Manufacturer Information

Fieldgate - FXA520 - all variants

New software version : 01.02.03-072

Fieldgate FXA 520 + FXA320 New Software Version 01.02.03-072

Linearization/SensorError/SensorTag Setup

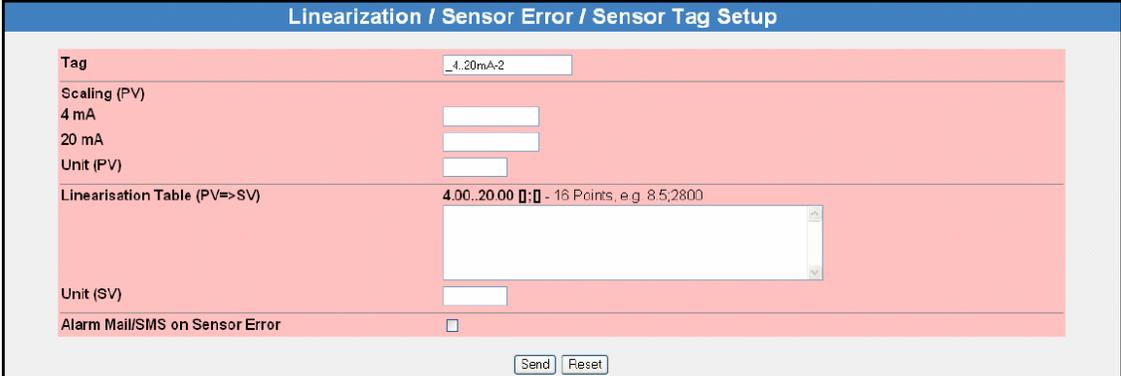
1.1 Linearization of 4-20mA inputs

For the internal 4-20mA analogue inputs, Fieldgate allows linearization with a linearization table. A maximum of 32 (16 FXA520) value pairs can be specified. The linearization table entries can be computed beforehand using a device tool such as the ToF Tool, for example, and copied into the appropriate field of the Fieldgate configuration using the "copy & paste" function.

Mail Configuration

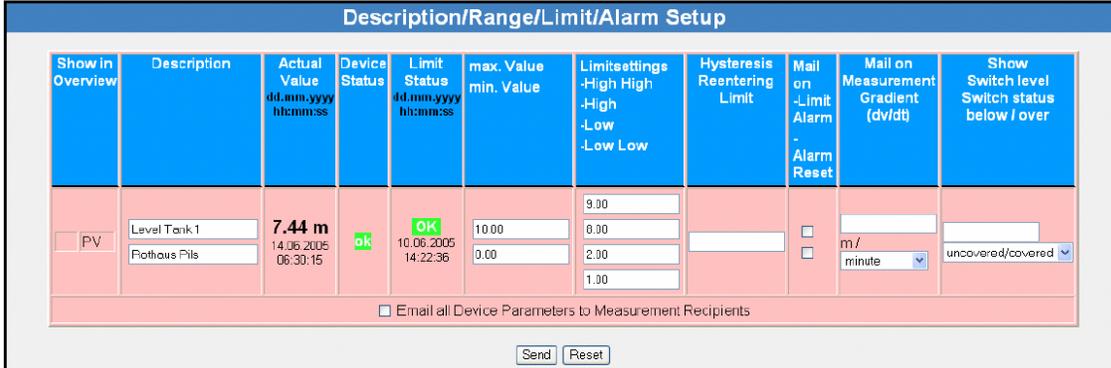
Send History Data Mail

History data are always sent in XML format.

Every time a measured value mail is sent, all the logged history data are sent to the recipients of the measured values in the form of one or more separate mails in XML format. Use this function if you want to cyclically send all the measured values recorded in the history over a specified period. The time interval is specified by the option selected under "Periodic Measurement Mails".

Every time the history memory overruns, its entire content is sent to the recipients of the measured values in the form of several mails in XML format. Use this function if you do not want to lose any measured values saved in the history in the event of history overrun.

Every time an event occurs, e.g. limit value violation or device errors, all the logged history data are sent to the recipients of the measured values in the form of one or more separate mails in XML format. This function makes it possible to analyze all the measured values saved before the event occurred.

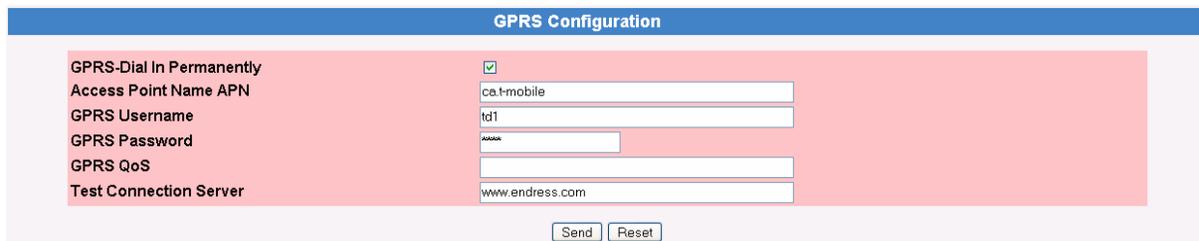
1.6 Unification of FXA320 and FXA520 user interface

Menu bar change: The HART Setup of the FXA520 is now located under "Scan Control".
